PIC16C64A Rev. A Silicon Errata Sheet

The PIC16C64A (Rev. A) parts you have received conform functionally to the Device Data Sheet (DS30234D), except for the anomalies described below.

FIGURE 1: SCK PULSE VARIATION USING TIMER2/2

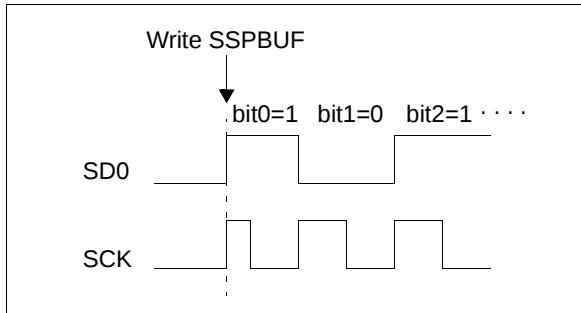
4. Module: SSP (SPI Mode)

When the SPI is using Timer2/2 as the clock source, a shorter than expected SCK pulse may occur on the first bit of the transmitted/received data (Figure 1).

To avoid producing the short pulse, turn off Timer2 and clear the TMR2 register, load the SSPBUF with the data to transmit, and then turn Timer2 back on. Refer to Example 1 for sample code.

FIGURE 1: WRITES TO TIMER1 (EXTERNAL CLOCK/OSCILLATOR MODE)

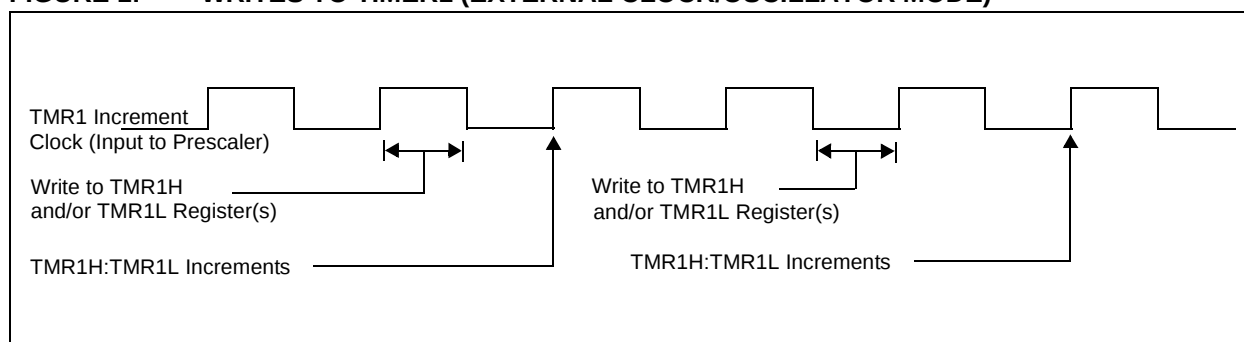
The operation of Timer1 needs some clarification when the timer registers are written and the TMR1ON bit is set.

The internal clock signal, that is the input to the TMR1 prescaler, affects the incrementing of Timer1 (TMR1H:TMR1L registers and the Timer1 prescaler). When the Timer1 registers are NOT written, the Timer1 will increment on the rising edge of the TMR1 increment clock.

When the TMR1H and/or TMR1L registers are written while this clock is high, TMR1 will increment on the next rising edge of this clock.

When the TMR1H and/or TMR1L registers are written while this clock is low, TMR1 will not increment on the next rising edge of this clock, but must first have a falling clock and the rising clock for TMR1 to increment.

Figure 1 shows the two cases of writes to the TMR1H and/or TMR1L registers. Due to the V_{IH} and V_{IL} thresholds on the oscillator/clock pins, external Timer1 oscillator components, and external clock frequency, the Timer1 increment clock may not be of a 50% duty cycle.

The TMR1 increment clock is out of phase of the T1OSO/T1CKI pin by a small propagation delay.
